**Notice of Policy Committee Meeting of Bathurst Regional Council -
Wednesday, 4 April 2018**

* DEVELOPMENT APPLICATION NO. 2017/448 – FIVE X TWO BEDROOM SELF CONTAINED UNITS AT 17 VINE STREET, SOUTH BATHURST. APPLICANT: HOUSING PLUS. OWNER: TRUSTEES ROMAN CATHOLIC CHURCH DIOCESE OF BATHURST

Council has received a Development Application (DA) for five x two bedroom self contained units at 17 Vine Street, South Bathurst, described as Lot 16 DP 263190. A location plan and aerial photo are provided at **attachment 1**.

DEVELOPMENT APPLICATION PROPOSED SITE PLAN

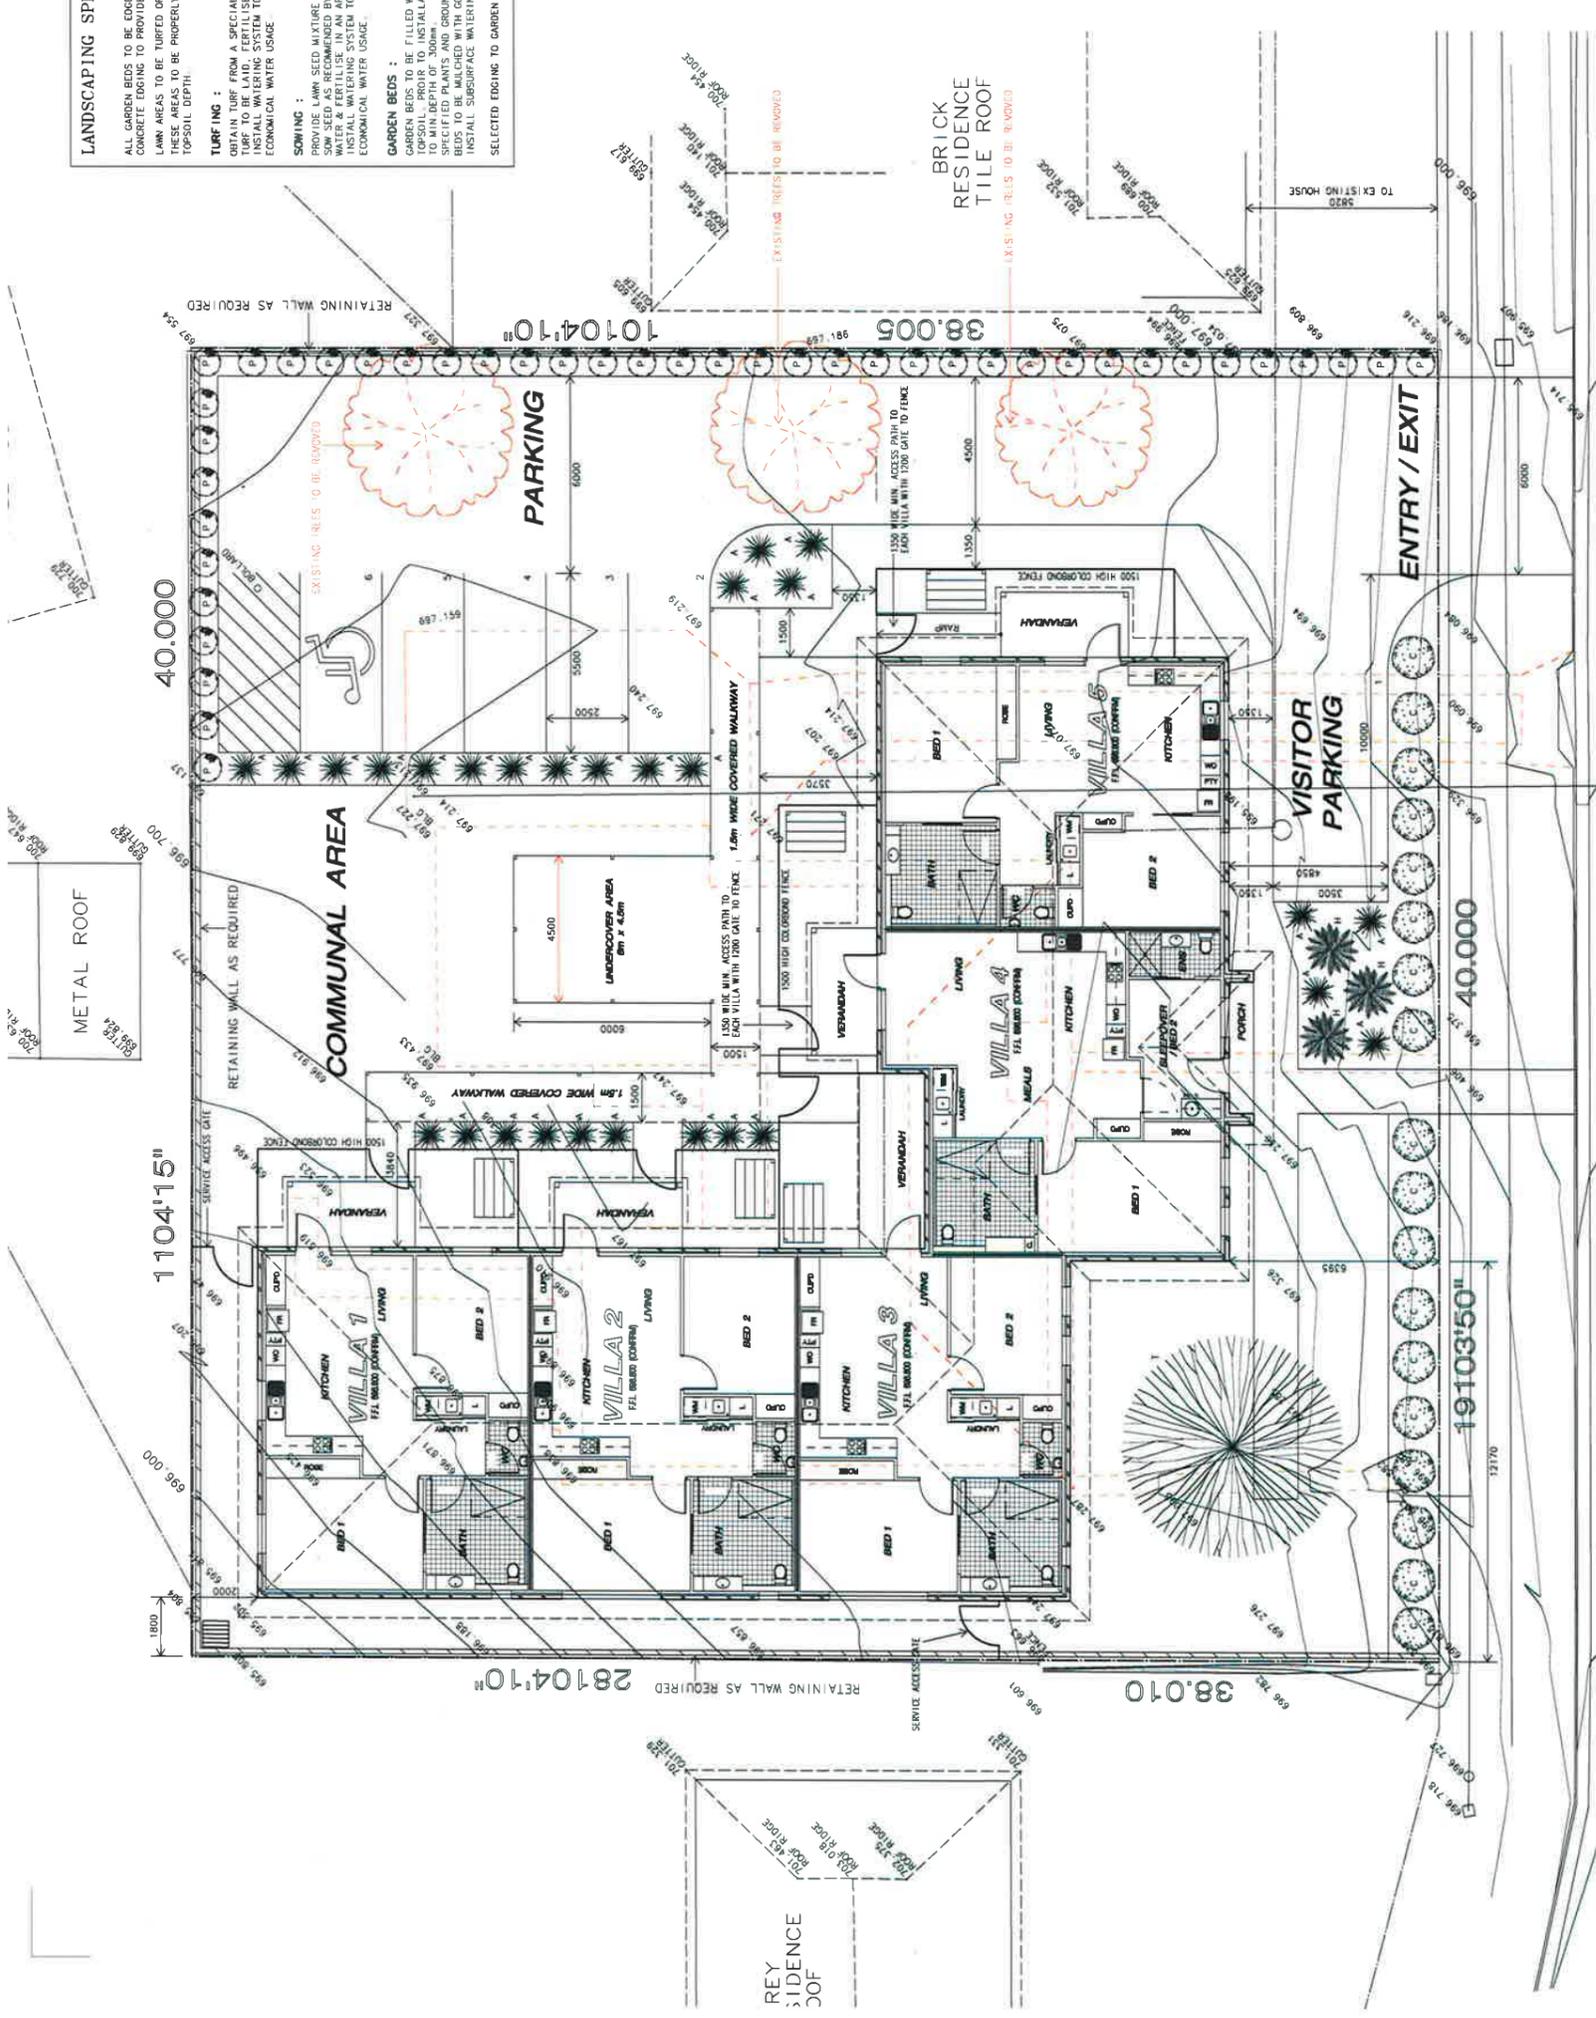
- SoEE has numerous references to incorrect planning instruments, property address and matters not shown on the DA plans;
- Further demonstration required for compliance with development standards of SEPP (Housing for Seniors and People with a Disability) 2004;

- Plans needed to show setbacks, consistency with setbacks in streetscape, details on heights and retaining walls, details on communal facilities (i.e. laundry).

On current proposal on Pg. 10 it is still stating 1.8M fencing when the catholic building code states on 1.5M on all the plans. Our concern is building a retaining wall and then a fence on top of that, this will not only not look good, it may block the sun coming into our property affecting the current garden beds.

The applicant resolved to amend both the SoEE and plans. New documentation was submitted on 21 February 2018. The application was then re-notified and re-advertised between 12 March 2018 to 26 March 2018. Following the advertising and notification period a total of 10 submissions were received at the time of preparing this report (see submissions at **attachment 4**).
